APPENDIX C7
COMMENTS RECEIVED

PROPOSED DEVELOPMENT OF THE PHAKWE RICHARDS BAY GAS POWER 3 COMBINED CYCLE POWER PLANT, RICHARDS BAY IDZ ZONE 1F, RICHARDS BAY, KWAZULU-NATAL.

COMMENTS ON THE DRAFT ENVIRONMENTAL IMPACT ASSESSMENT REPORT FOR THE PROPOSED PHAKWE RICHARDS BAY GAS POWER 3 COMBINED CYCLE POWER PLANT (CCPP) AND ASSOCIATED INFRASTRUCTURE WITHIN THE RICHARDS BAY IDZ PHASE 1F, RICHARDS BAY, CITY OF UMHLATHUZE LOCAL MUNICIPALITY, KWAZULU-NATAL PROVINCE

COMMENTS ON THE PROPOSED DEVELOPMENT OF THE PHAKWE RICHARDS BAY GAS-TO-POWER 3 2000MW COMBINED CYCLE POWER PLANT, RICHARDS BAY IDZ ZONE 1F, RICHARDS BAY, KWAZULU-NATAL PROVINCE (DEFF Reference No.: 14/12/16/3/3/2/2117)

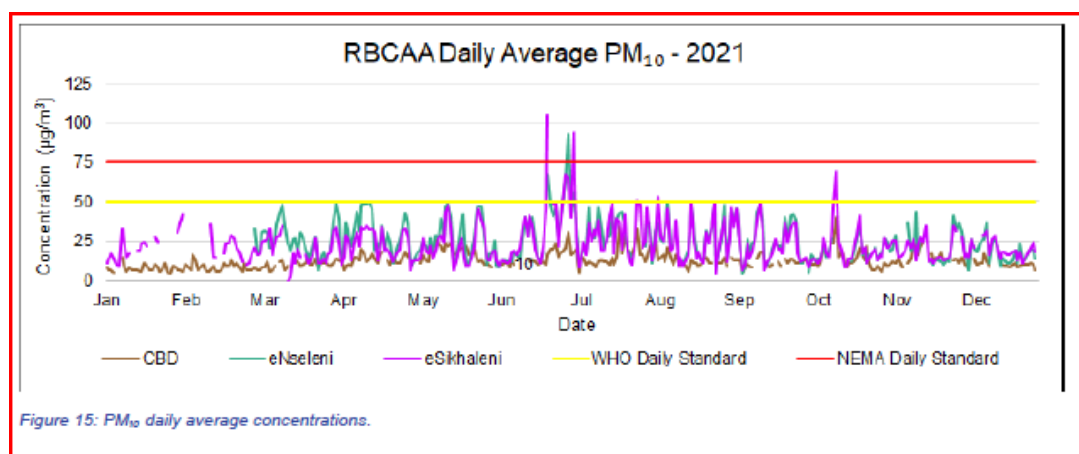
- 5. RBCAA Esikhaleni and eNseleni Data;** Table 5-7 shows zero (0) exceedances recorded at eNseleni during 2021. This is not correct. There was one (1) exceedance of PM₁₀ Daily NEMA Standard (75 µg/m³) recorded at the eNseleni station during 2021.

Table 5-8 shows zero (0) PM10 exceedances recorded at Esikhaleni. This is not correct. There were two (2) exceedances of the PM₁₀ Daily NEMA Standard (75 µg/m³) recorded at the Esikhaleni station during 2021
